Access Compliance Report Public Rights-of-Way (Curb Ramps)

Main Street: ERVIN_LN Cross Street: SANDHURST_ST Location: SE

ADA ID: RPAT211007125941 Ramp Type: Type 1 - Perpendicular Diagonal Initial Pass/Fail: Pass Overall Compliance: No Severity Score: 25

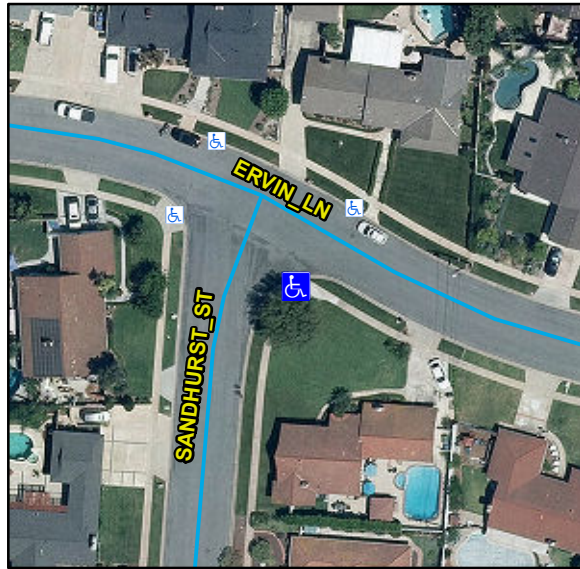
Compliance	Description	Data	Compliance	Description	Data
N/A	Ramp Length (in)	124	N/A	Flare Type LT	
Yes	Ramp Width (in)	48			Sloped
Yes	Ramp Run Slope (%)	7.6	N/A	Flare Slope LT (%)	7.1
Yes	Ramp Cross Slope (%)	1.5	N/A	Flare Traversable LT	No
N/A	Landing Present	No	N/A	Flare Type RT	
N/A	Landing Length (in)	N/A			Sloped
No	Landing Width (in)	N/A	N/A	Flare Slope RT (%)	5.3
No	Landing Run Slope (%)	N/A	N/A	Flare Traversable RT	No
No	Landing Cross Slope (%)	N/A	No	DWS Provided	No
N/A	Landing Movement Obstructed?	No	N/A	DWS Contrast	N/A
	Landing Movement Type	N/A	N/A	DWS Length (in)	N/A
N/A	Landing Shared	N/A	N/A	DWS Full Width	N/A
N/A	Clear Space	Yes	N/A	DWS Offset Left (in)	N/A
N/A	Clear Space To Crosswalk (in)	48	N/A	DWS Offset Right (in)	N/A
N/A	Marked Crosswalk 1	No	N/A	Marked Crosswalk 2	No
	Crossing 1 Direction	N		Crossing 2 Direction	W
	Marked Crosswalk 1 Width (in)	N/A		Marked Crosswalk 2 Width (in)	N/A

N/A	Ramp Inside Crosswalk 1	N/A	Yes	Ramp Inside Crosswalk 2	N/A
	Crossing 1 Slope (%)	3.6		Crossing 2 Slope (%)	2.2
	Crossing 1 Cross Slope (%)	0.4		Crossing 2 Cross Slope (%)	2.2
Yes	Gutter Ponding	No	Yes	Curb Slope	2.4
Yes	Gutter Lip Height (in)	0		Road Run Slope (%)	2.1
No	Gutter Run Slope (%)	6.3		Road Cross Slope (%)	6.5
Yes	Gutter Cross Slope (%)	0.9			
Yes	Overall Surface Condition: Acceptable		No	Perp Joint Present	No
	Cross Gutter Present?	No		Spandrel Present?	No
	Replace Cross Gutter?	N/A		Replace Spandrel?	N/A

Remove & Replace Curb Ramp With Two New Directional Ramps or Equivalent. Remove & Replace Gutter.
